To: Nick Sugar, City Planner and Amanda Krickovich, Community Development, City of Hudson
From: Olivia Hopkins, AIA | Historic Architecture, Perspectus
Date: April 18, 2024
Re: 172 Aurora Street
CC: Lauren Pinney Burge, AIA, Principal & Alice Sloan, Assoc. AIA, APT-RP | Historic Architecture, Perspectus

SUBJECT PROPERTY: 172 Aurora Street

Image 3: Front (north) elevation. The orange box indicates the 1913 addition. The green box indicates the 1925 addition. The blue box indicates an addition with an unknown date.

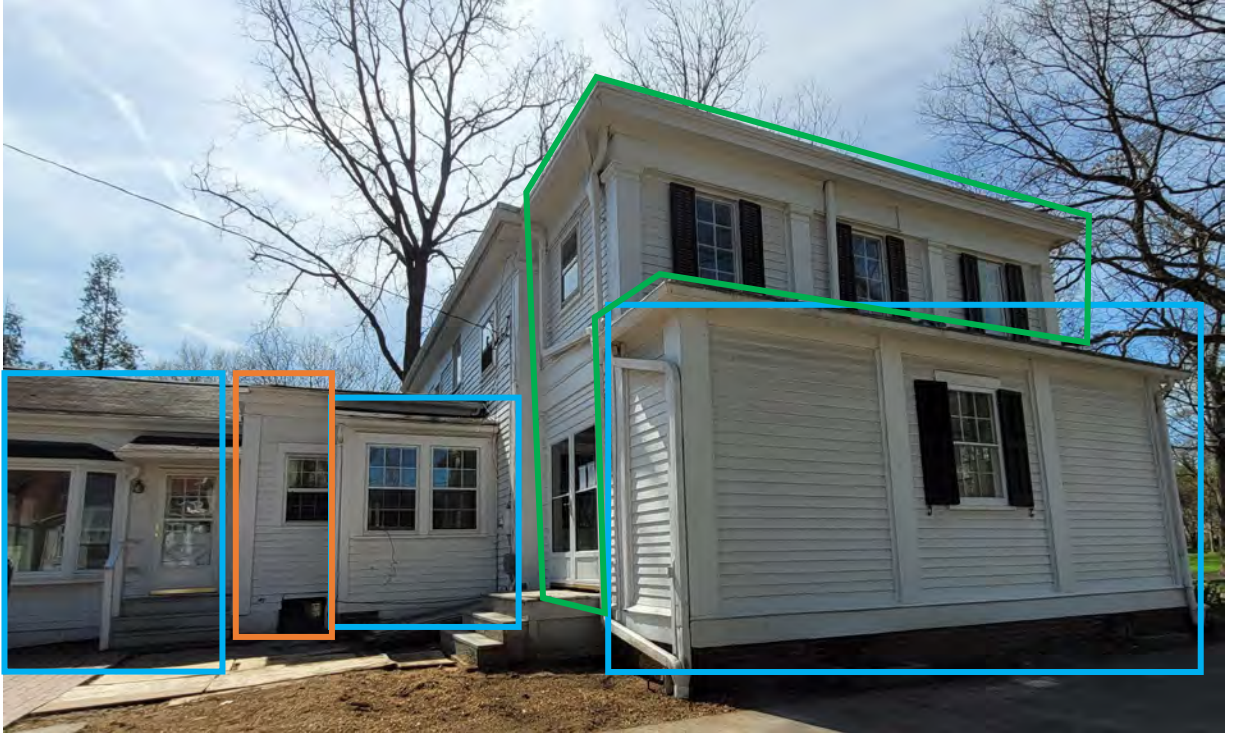
1. **Proposed Changes #1-3** are not appropriate because of the proposed removal of what appears to be historic materials from the site. The Secretary of the Interior Standards (SIS), #4, states that “changes to a property that have acquired historic significance in their own right will be retained and preserved.” The period of significance for the District ends in 1963, any modifications which have happened up to c1963 have acquired historical significance. Note the construction date of the rear-most addition, which attaches to the 1913 addition, is unknown, but appears to date to within the period of significance based upon cursory observations of the condition of the wood materials.
